2190098

## **SECTION 4.55(2) MODIFICATION – BUILDING C1, BARANGAROO SOUTH INSTALLATION OF CO-GENERATOR**

This application has been prepared by Ethos Urban on behalf of Lendlease (Millers Point) Pty Ltd pursuant to section 4.55(2) of the *Environmental Planning and Assessment Act 1979* (EP&A Act) to modify Development Consent SSD 17\_8529 relating to Building C1 at Barangaroo South.

**Figure 2 Location of cogeneration plant at ground level**

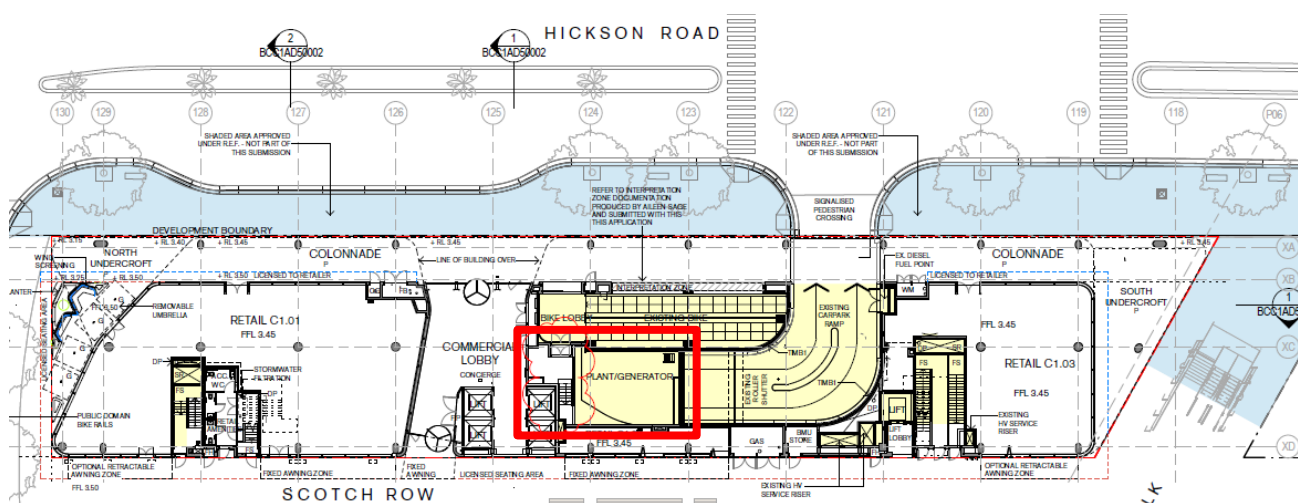
An onsite cogeneration plant comprised of two used cooking oil fired 270 kW Volvo Penta TAD1342GE engines will be installed at the ground and mezzanine levels within the existing plant room. The cogeneration plant will be fuelled by refined UCO and generate electricity and heat for local consumption and will operate 24 hours a day, 7 days a week. The location of the cogeneration plant is shown at **Figure 2**.

**Figure 3 Location of cogeneration plant exhaust at roof level**

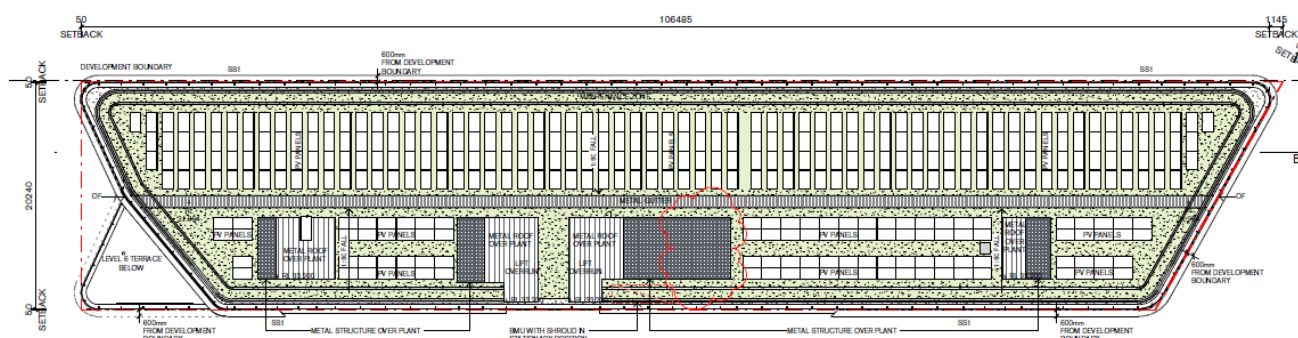
A 1 metre high exhaust will be located within the existing plant area on the roof.

**Figure 4 Proposed exhaust flues at roof level**

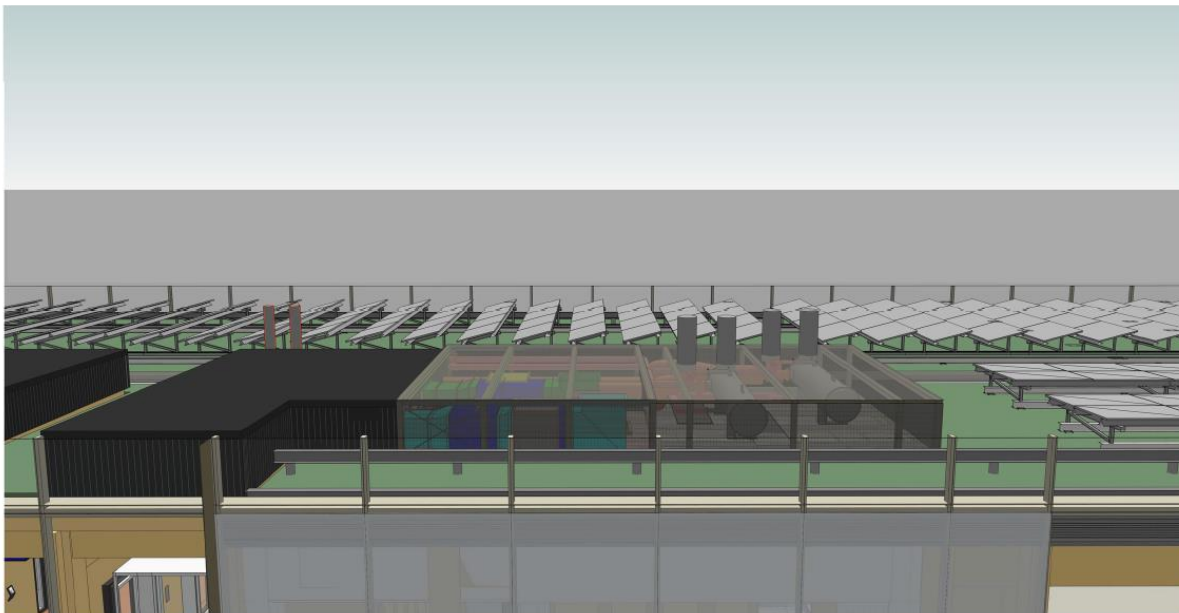
The co-generator is contained within the plant room located on the ground and mezzanine levels of Building C1 and will not be visible from the public domain. The addition of a 1 metre high exhaust flue is located within the approved plant location on the roof and will not significantly alter the appearance of this area, as shown at **Figure 4**.
